REVISION ON ACTIVE PERMIT

JOB ADDRESS 2635 Land Ave SUITE PERMIT NO 00-05575C

DESCRIPTION OF REVISIONS E-1 One Line Diagram

PERMIT # 00-05575
 ELECTRICAL
 REVISED 7/7/00

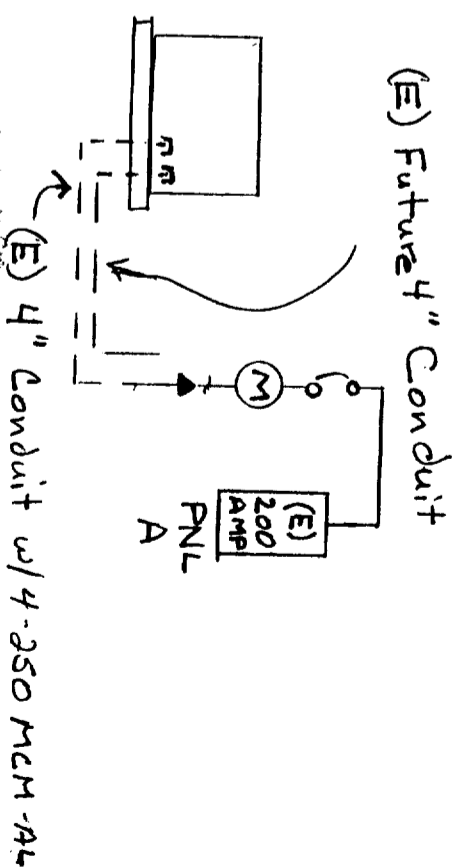
- ① EXISTING 4/0 CU UFERR GRD, REMOVE FROM (E) 200A MAIN, ROUTE THROUGH (N) 4x4x12 GUTTER. CAD WELD 4/0 EXTENSION TO NEW 200A MAIN GUTTER RECONNECT (E) UFERR TO (E) 200A METER MAINS around (E) na. of roof (overhead)
- ② CUT AND CAP (E) 4" CONDUIT REMOVE (E) 200 MCM AL CONDUCTORS, REFEED (E) METER FROM (N) GUTTER ABOVE
- ③ PROVIDE K/O SEAL WHERE CONDUIT HAS BEEN REMOVED
- ④ EXTEND (E) 1" FUTURE CONDUIT INTO (N) 400 AMP GUTTER W/ 4-500 MCM CU SECONDARY CONDUCTORS ABOVE METERS
- ⑤ PROVIDE 300MCM X/S SPLICER KIT IN (N) GUTTER. CONNECT 3/5 TO (E) AND (N) METERS.
